Rezoning Transportation Analysis
Petition Number: Insert Zoning Petition #2021-201
General Location Identifier: Tax ID 12709305

Revision Log:

Date	Description
12-23-21	First Review (WB)
02-21-21	Second Review (WB)
04-25-22	Third Review (WB)

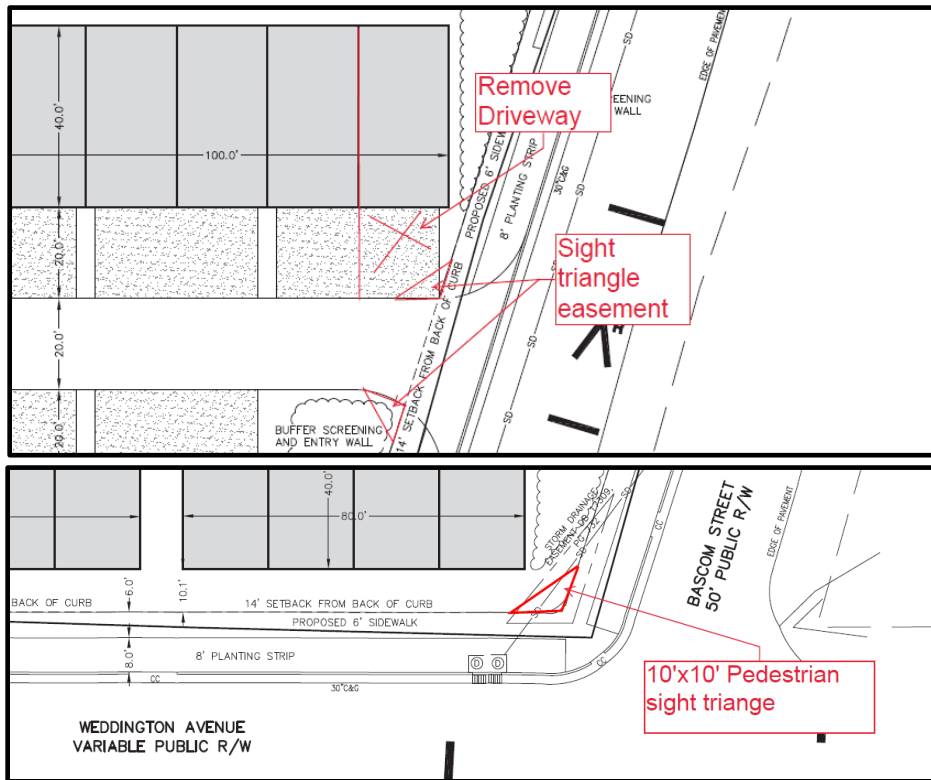
2. **Traffic Study:**
~~A Traffic Impact Study (TIS) is not necessary for the complete review of this petition due to the site generating less than 2,500 daily trips. If during the permitting process the site generates more than 2,500 daily trips, then a traffic study will be required.~~

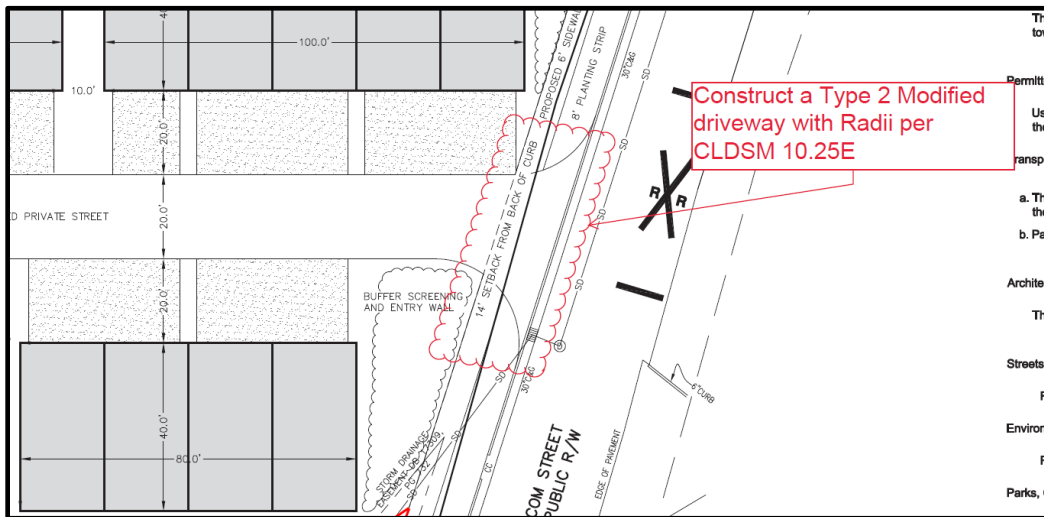
5. ~~Site plan and conditional notes revisions are needed to provide 10’ x 10’ pedestrian sight distance easements for any portion of the pedestrian sight triangles located outside the right of way and within the development. Remove proposed driveway from the pedestrian sight triangle. The pedestrian triangle measures 10 feet x 10 feet with one leg measured along the back of sidewalk or right of way (whichever is the greater distance from the curb line) and the other leg measured along the driveway face of curb or edge of pavement. Also provide Pedestrian sight triangles at the intersection of Weddington avenue and Bascom Street.~~

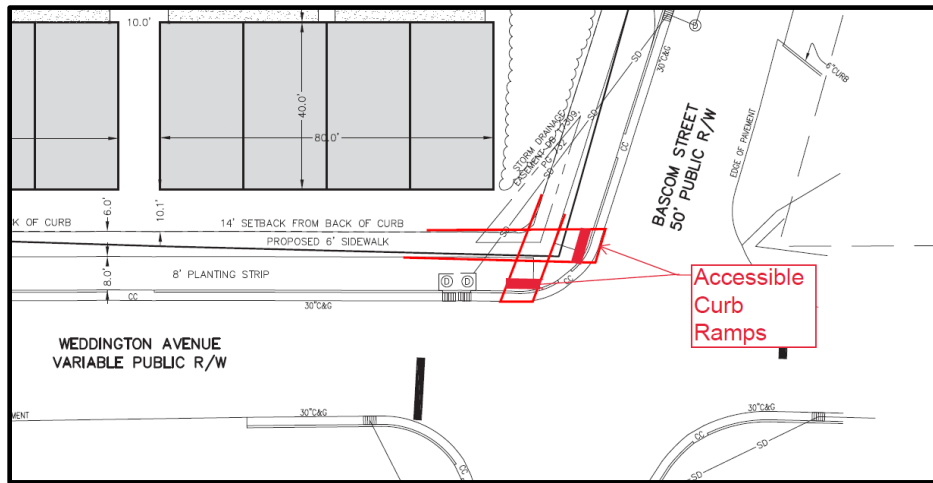
7. ~~Revise Site plan to construct two (2) accessible curb ramps at the intersection per PROWAG and ADA law.~~
